## **Packet Guide**

BAR 21-07-01

854 Locust Avenue, Tax Parcel 510092000

Project: Garage construction

854 LOCUST AVE - Plans

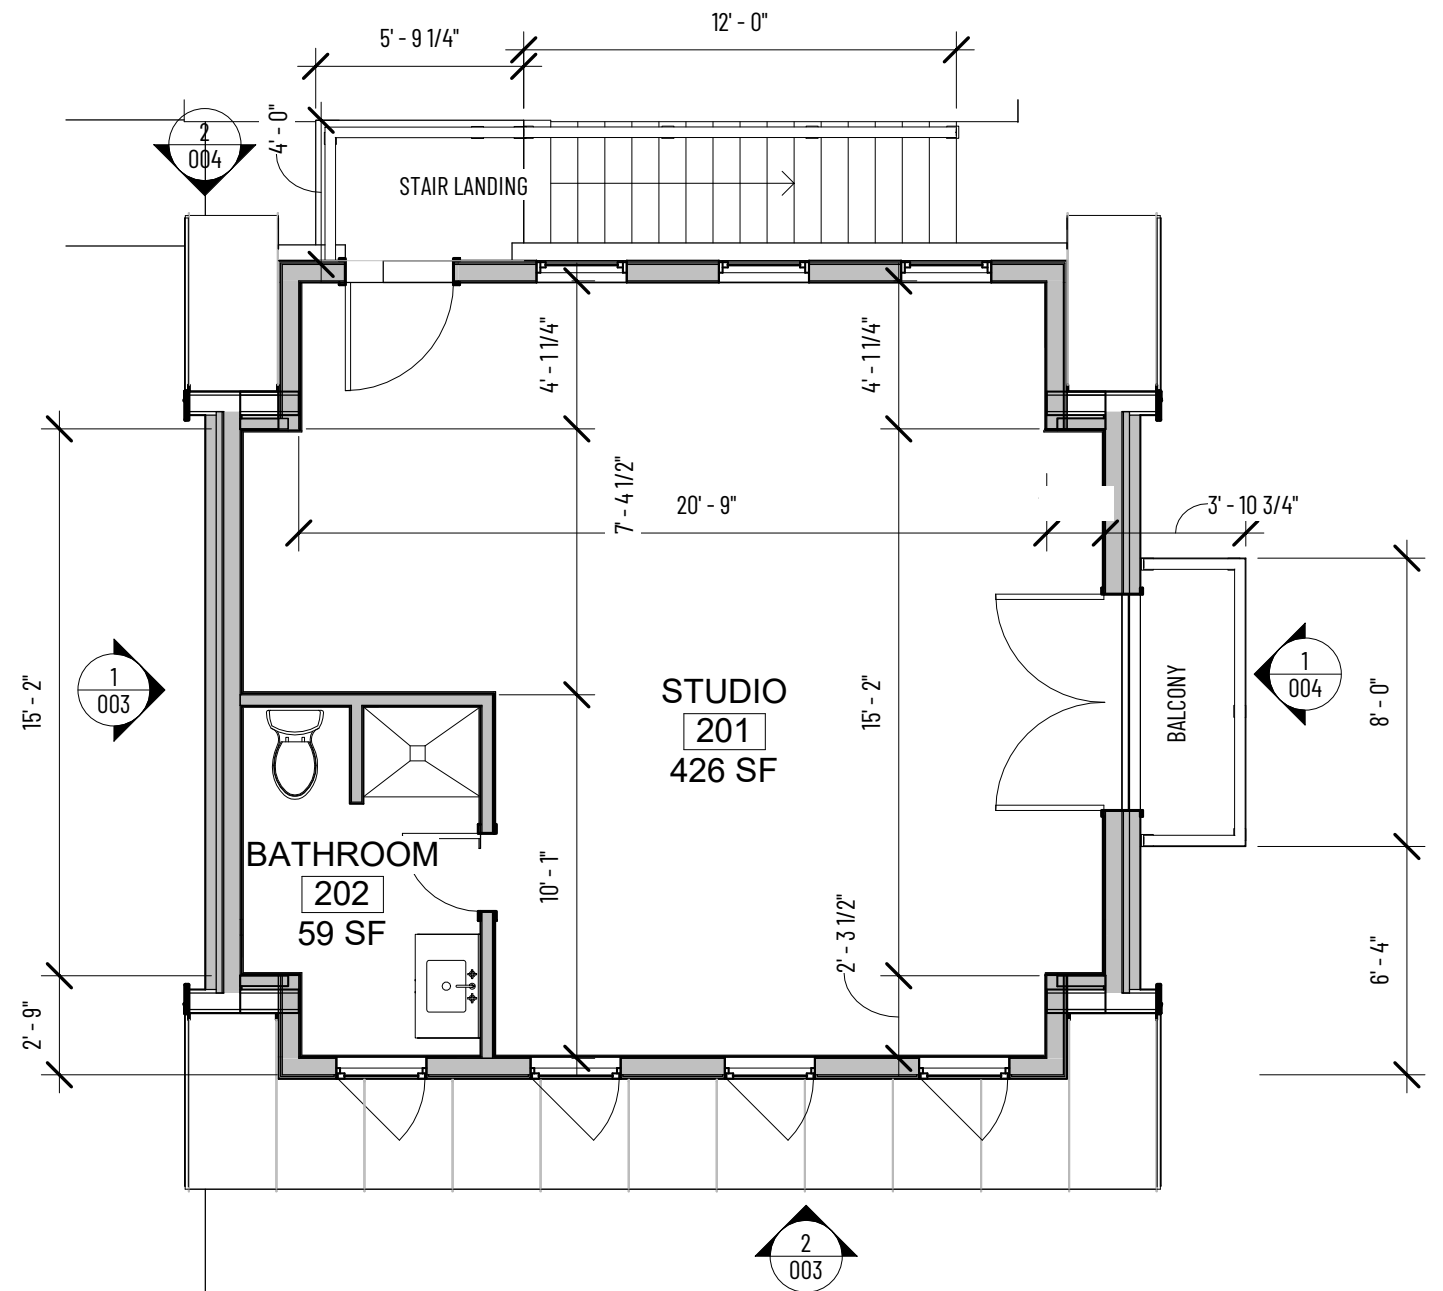
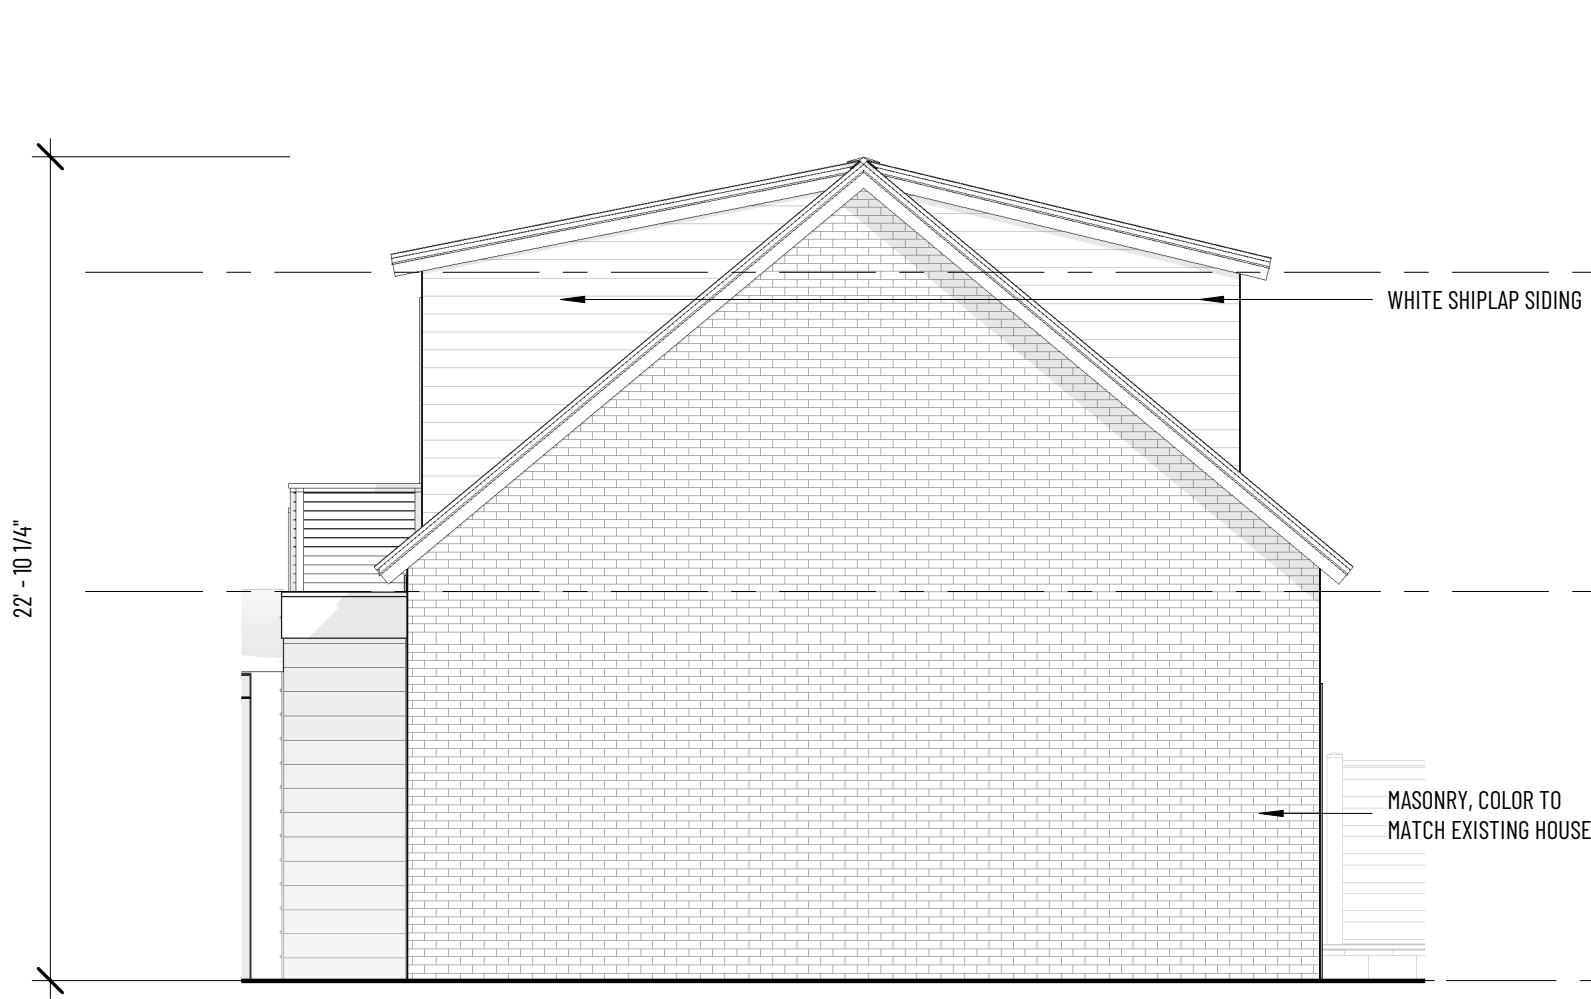
**Staff Comment:** Proposed garage is located in the rear yard and features a standing-seam metal roof.

854 LOCUST AVE - Elevations

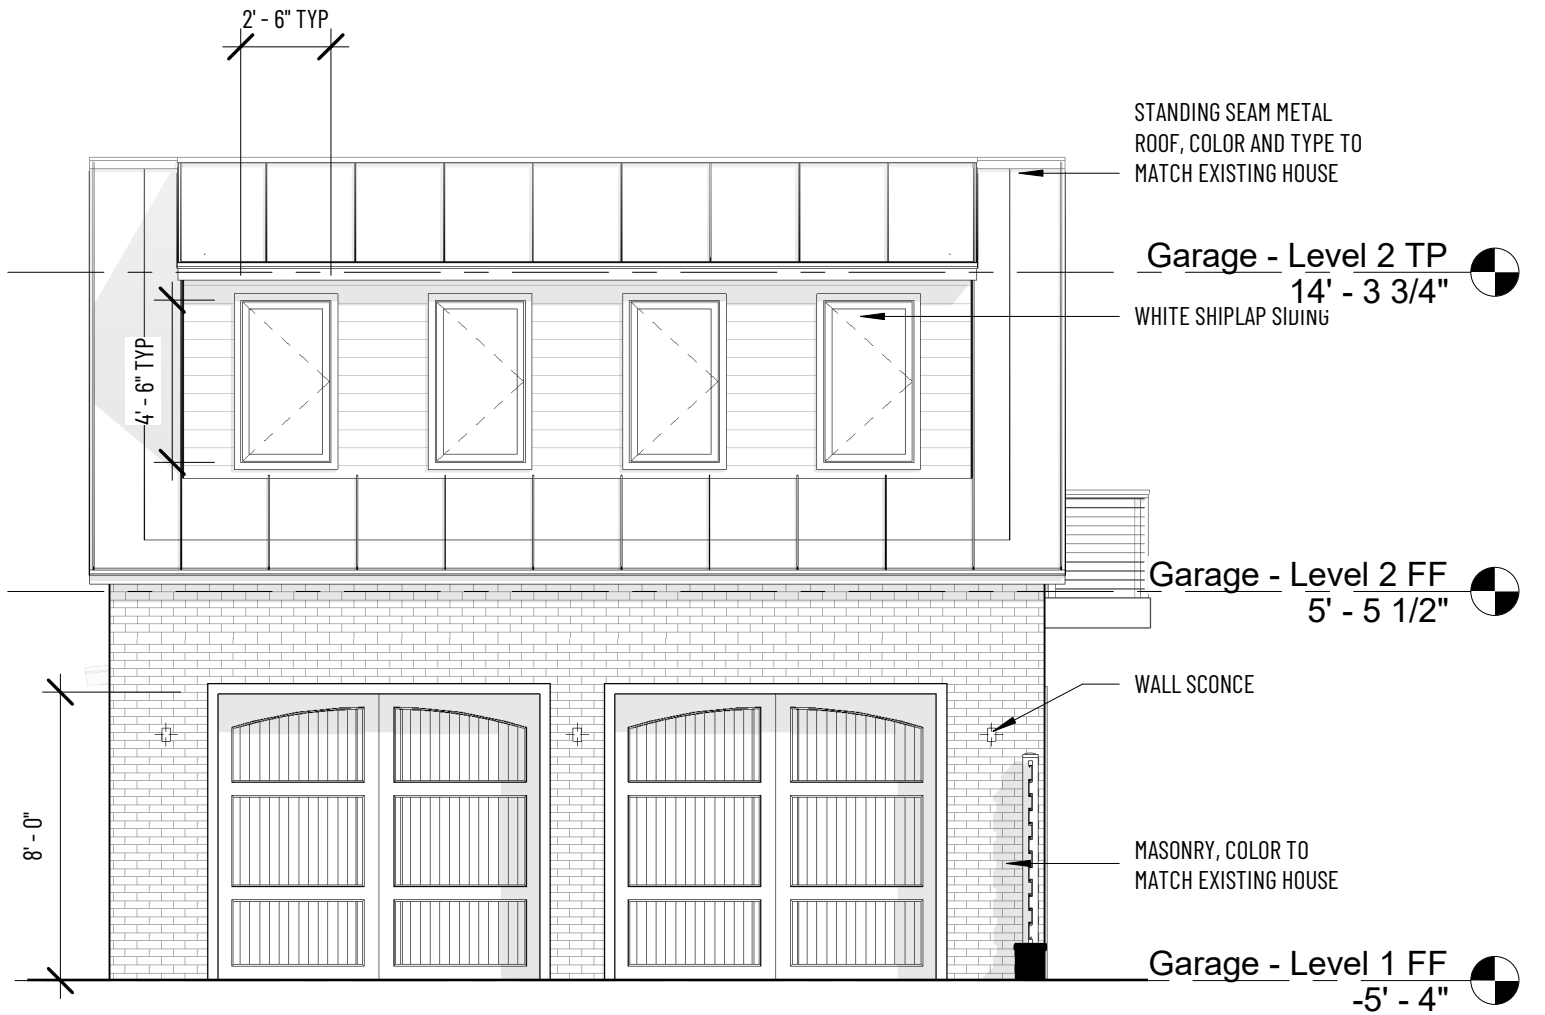
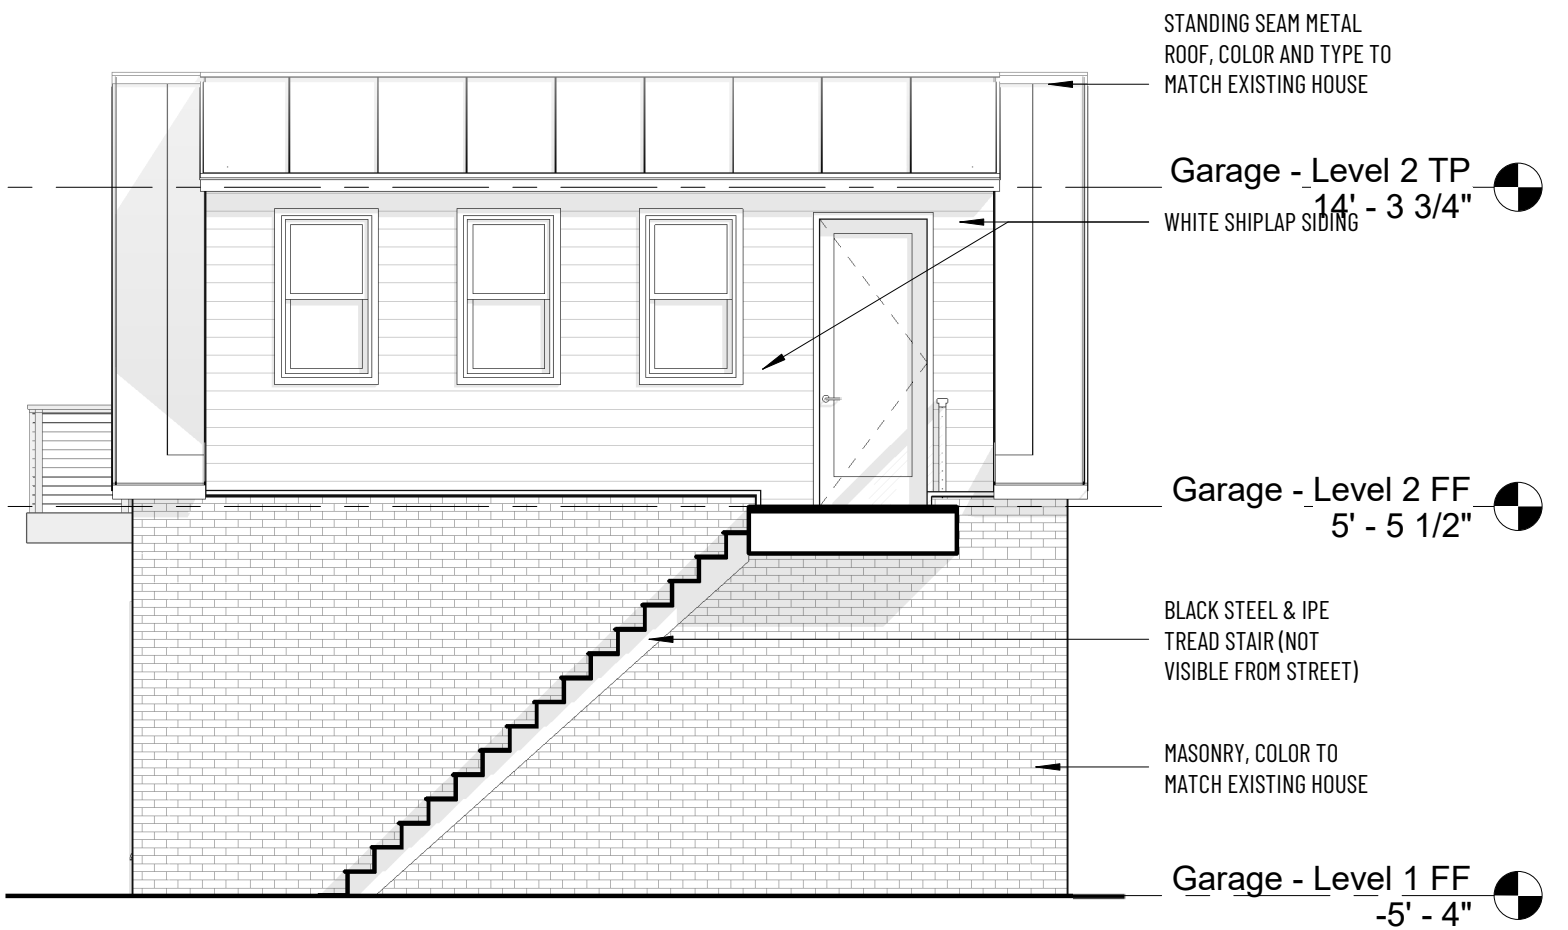
**Staff Comment:** The garage roof material and form are compatible with the HCD.

**Staff Comment:** The garage is oriented towards the street. The arrangement and style of the doors and windows are compatible with the HCD.
